1
2 **DOCUMENT 00 91 13**
3

8 ADDENDUM NO.1 Date: 08.02.21
9

10 RE: SAUK COUNTY COURTHOUSE AND HUMAN SERVICES BUILDING RENOVATIONS
11 515 OAK STREET, BARABOO, WI 53913 and
12 425 6TH STREET, REEDSBURG, WI 53959
13

1 UPPER LEVEL DEMOLITION FLOOR PLAN
1/8" = 1'-0"

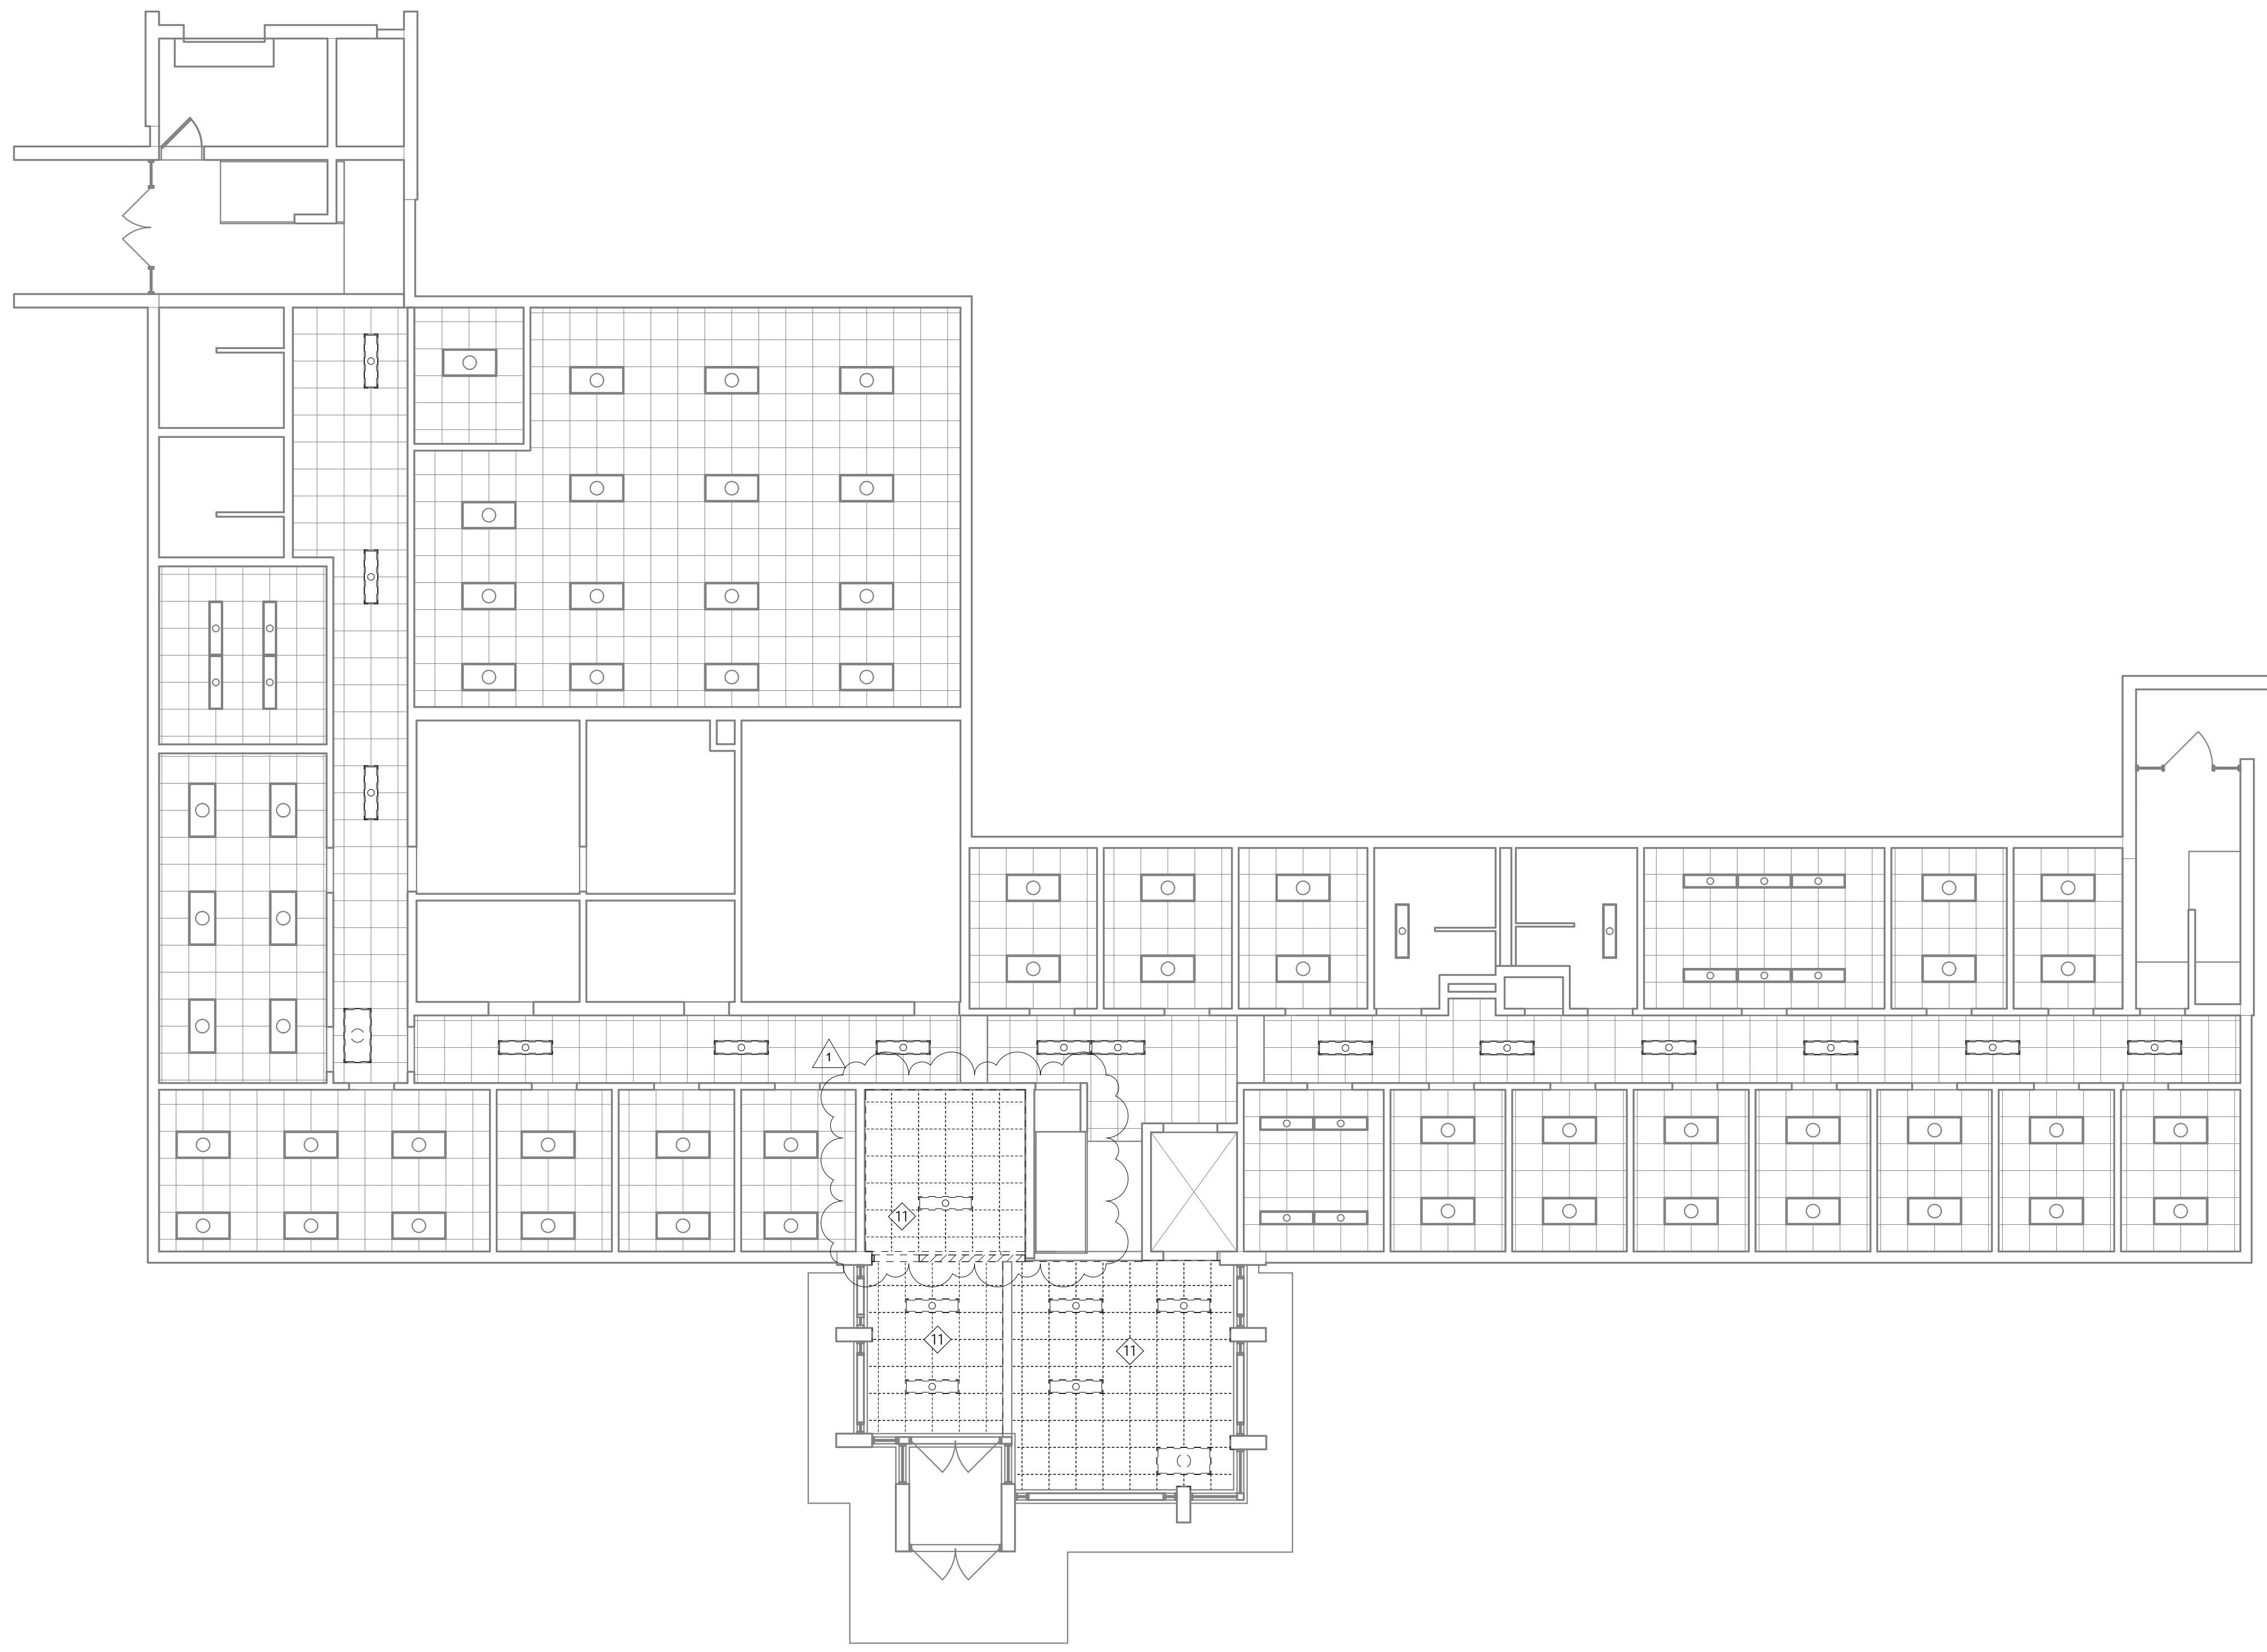
- 8
- 9 12. SHEET D201.2, UPPER LEVEL DEMOLITION FLOOR PLAN
- 10 c. Replace sheet D201.2 in its entirety with attached D201.2.
- 11 d. Revised Office G03 to reflect existing conditions.

1 LOWER LEVEL DEMOLITION CEILING PLAN
1/8" = 1'-0"

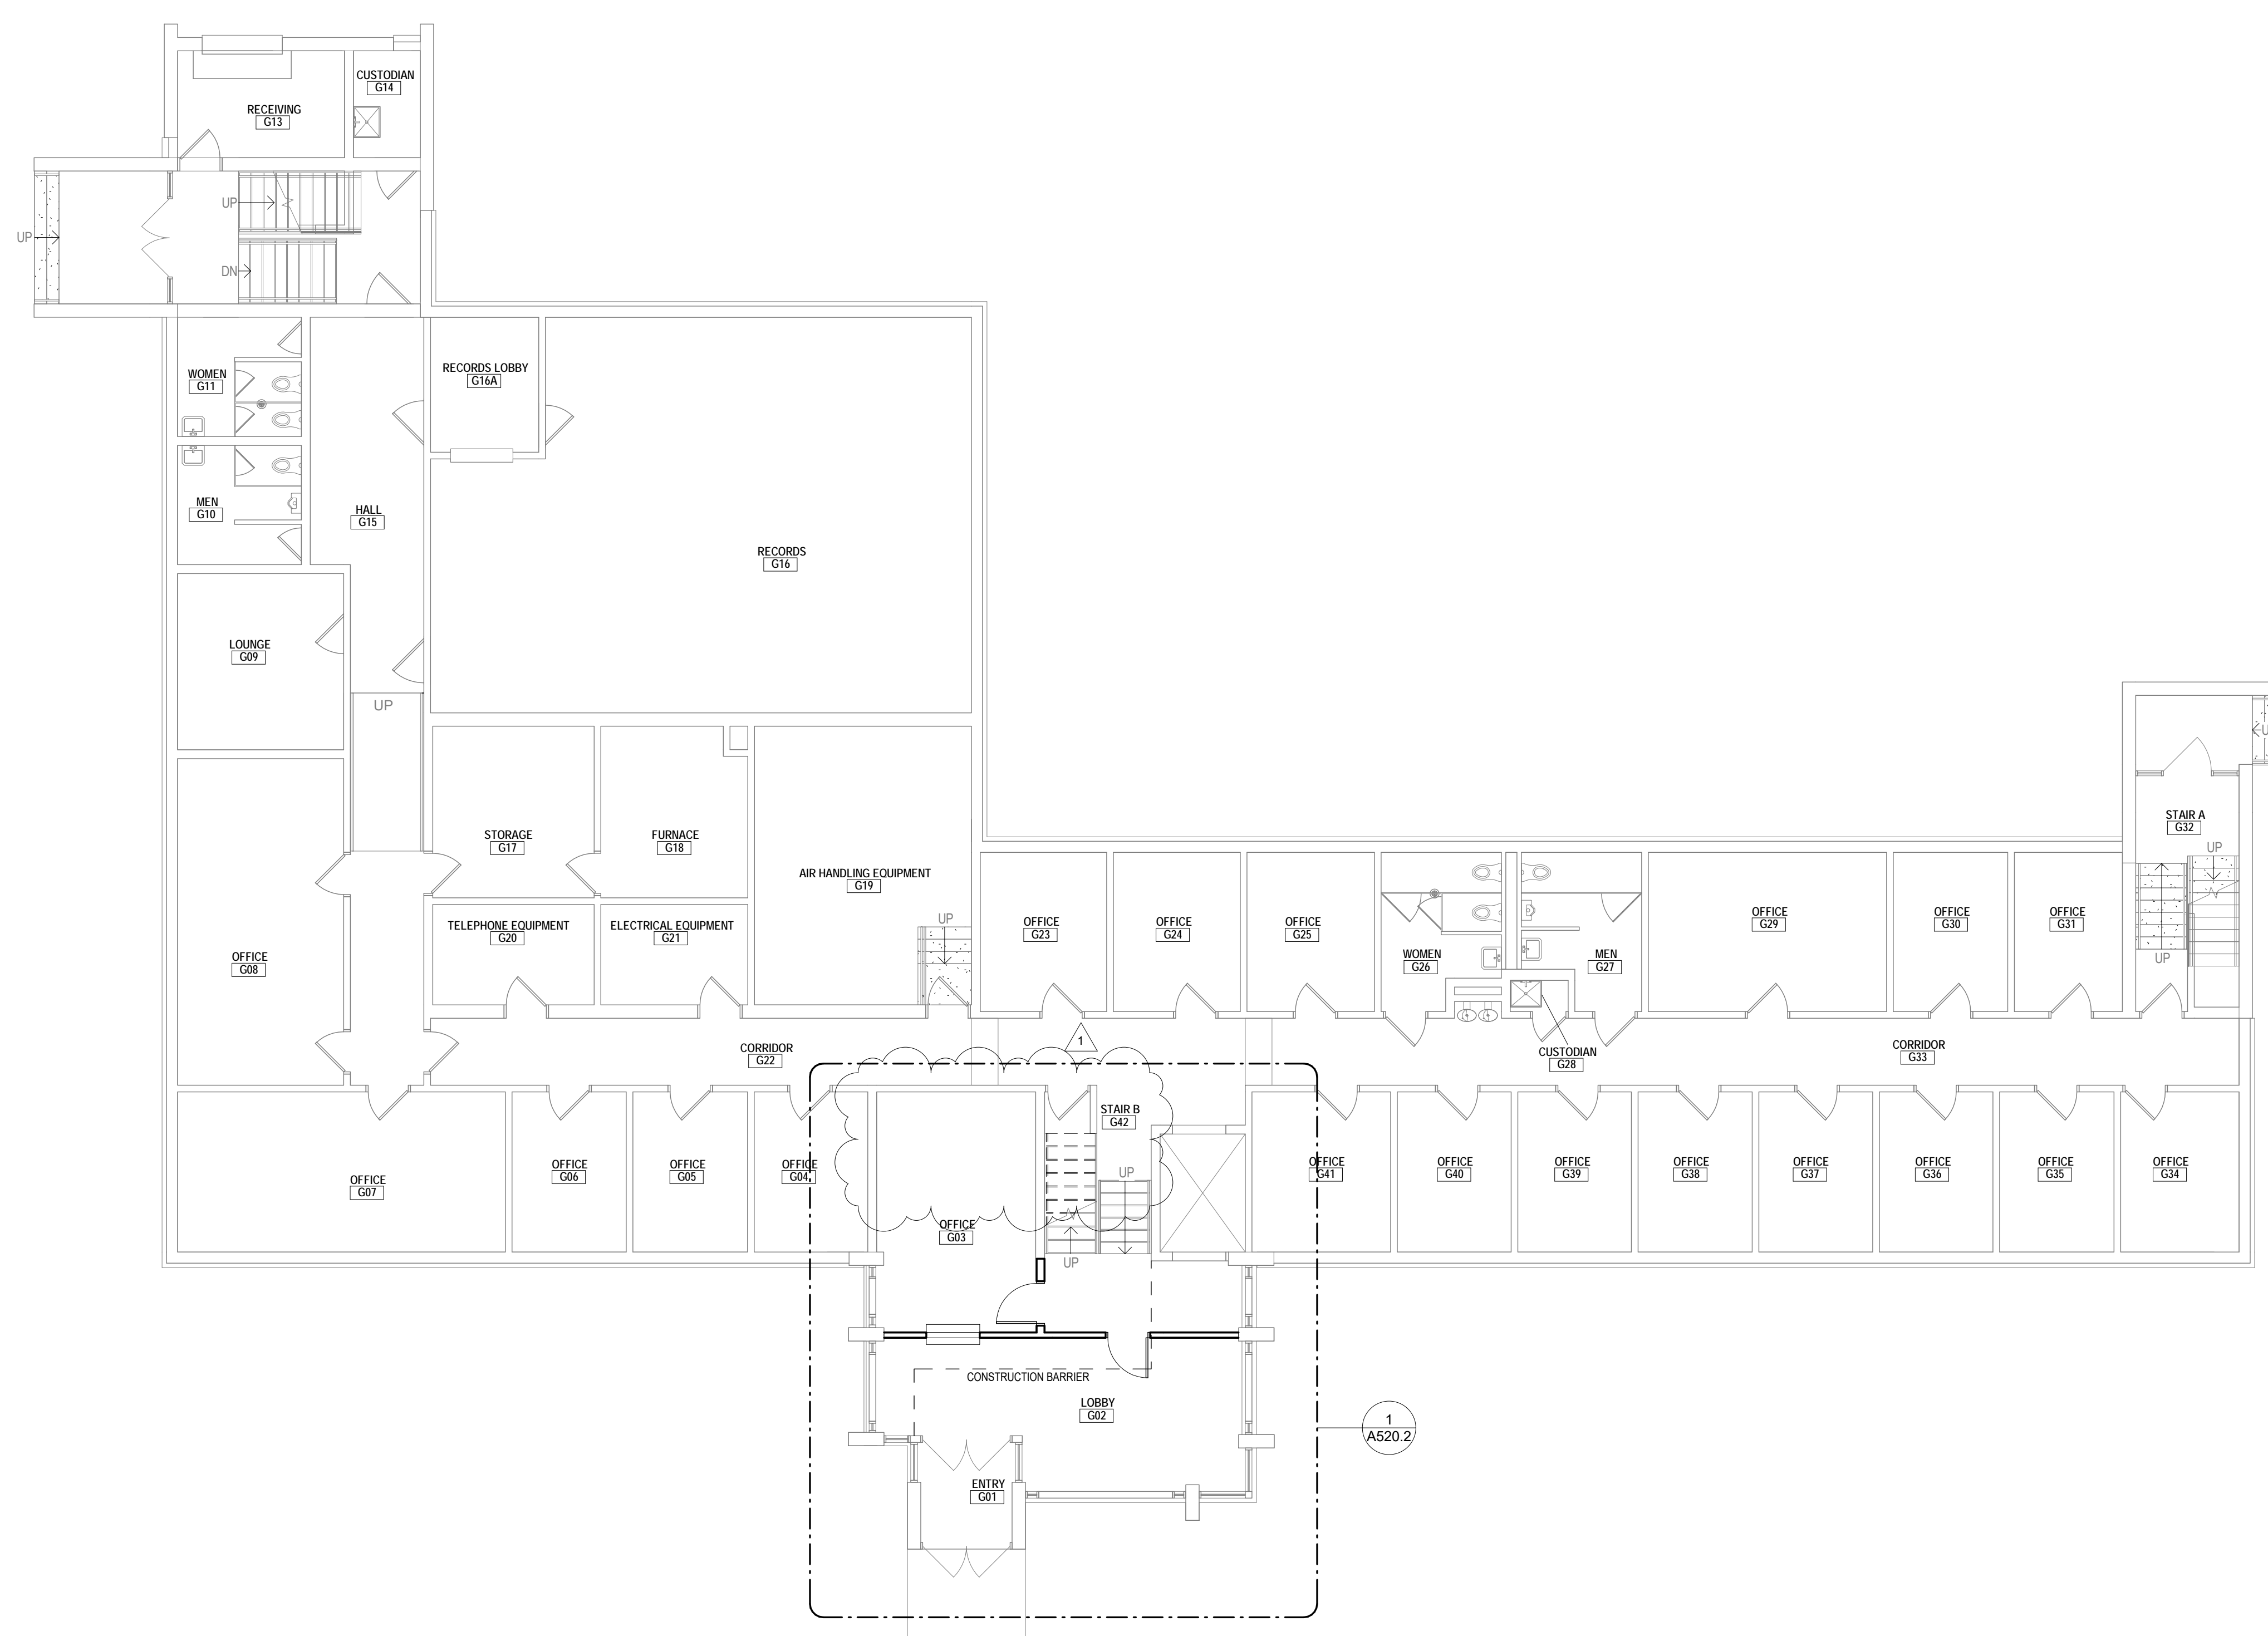
- 12
- 13 13. SHEET D300.2, LOWER LEVEL DEMOLITION CEILING PLAN
- 14 e. Replace sheet D300.2 in its entirety with attached D300.2.
- 15 f. Revised Office G03 to reflect existing conditions.

1 LOWER LEVEL REFLECTED CEILING PLAN
1/8" = 1'-0"

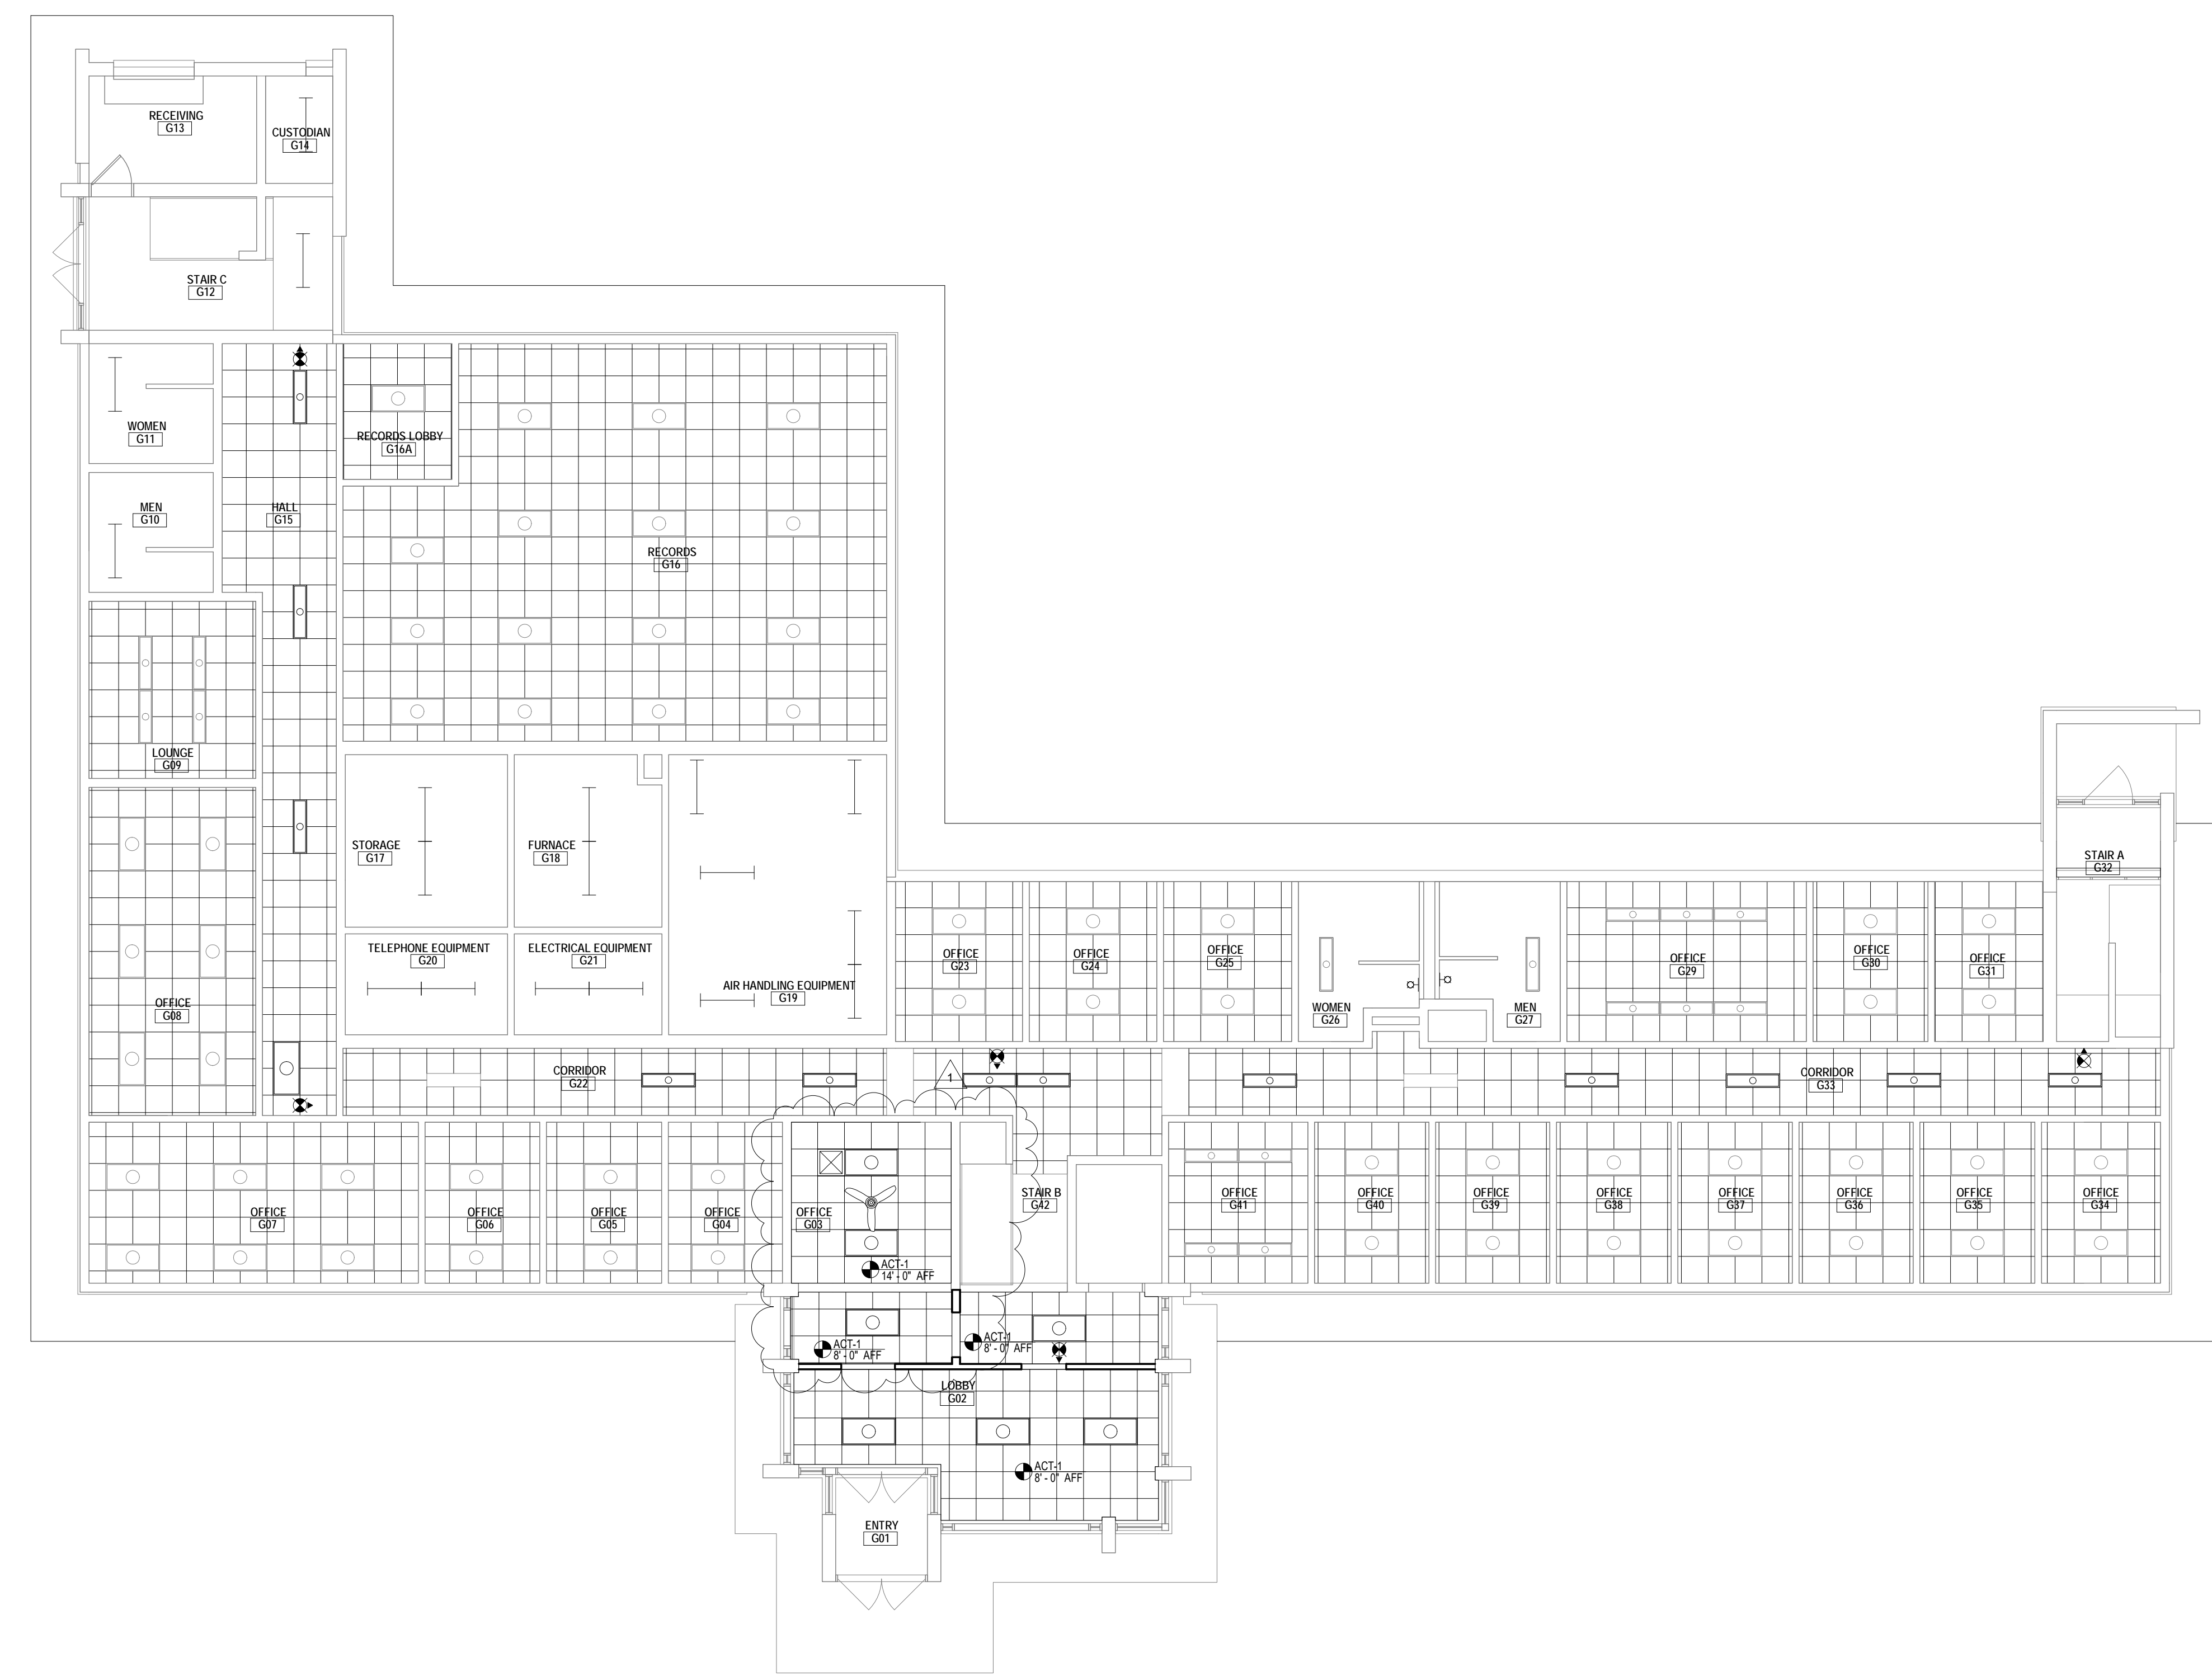
- 20
- 21 15. SHEET A300.2, LOWER LEVEL REFLECTED CEILING PLAN
- 22 a. Replace sheet A300.2 in its entirety with attached A300.2.
- 23 b. Revised Office G03 to reflect existing conditions.
